Access Compliance Report

Public Rights-of-Way

Intersection ID: 21262	Main Street: CARMEL_RD	Cross Street: PELLYN_WOOD_DR	Location: NE
ADA ID: A1EDB0032D92	Ramp Type: PerpDiag	Initial Pass/Fail: Fail	Overall Compliance: No
		Severity Score: 37.5

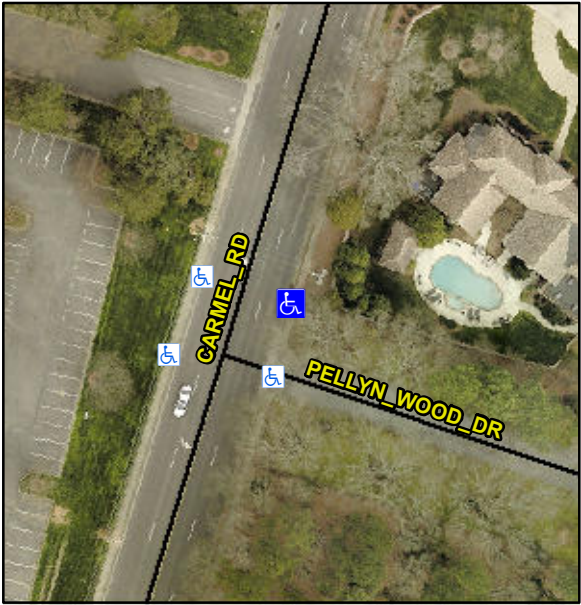
Codes/Mitigation Info/Possible Solution			Field Measurements/Component Compliance		
	Possible Solutions:		Compliance	Description	Data
	Remove & Replace Curb Ramp With Two New Directional Ramps or Equivalent.		No	Ramp Length (in)	48.0
			Yes	Ramp Width (in)	48.0
			N/A	Flare Type LT	N/A
			N/A	Flare Slope LT (%)	N/A
			N/A	Flare Traversable LT?	N/A
			N/A	Landing Length (in)	N/A
			N/A	Landing Width (in)	N/A
			N/A	Landing Slope (%)	N/A
			N/A	Landing X Slope (%)	N/A
<p>Surveyor Notes:</p> <p>N/A</p> <p>PROW/ADA:</p> <p>Not Found, R304.2.2, R304.5.3</p>			N/A	Flare Type RT	N/A
			N/A	Flare Slope RT (%)	N/A
			N/A	Flare Traversable RT?	N/A
			N/A	DWS Provided?	N/A
			N/A	DWS Contrast?	N/A
			N/A	DWS Length (in)	N/A
			N/A	DWS Full Width?	N/A
			N/A	DWS Offset (in)	N/A
			N/A	Gutter Ponding?	N/A
			N/A	Gutter Lip Ht (in)	N/A
			No	Painted X Walk1?	No
				X Walk 1 Direction	To NW
			N/A	X Walk 1 Width (in)	N/A

3.1	X Walk 1 Slope (%)	3.4
			0.2	X Walk 1 X Slope (%)	4.5
			N/A	Ramp inside XWalk1?	N/A
			5.0	Road Slope (%)	N/A
			0.2	Road X Slope (%)	N/A
			N/A	Any Obstructions?	N/A
				Obstruction Type	
Total Cost: \$ 3200.00			N/A	Storm Grate/Utility Hazard?	N/A
			N/A	Storm Grate/Utility Type	N/A
			Yes	Surface Condition? (G/P)	Good
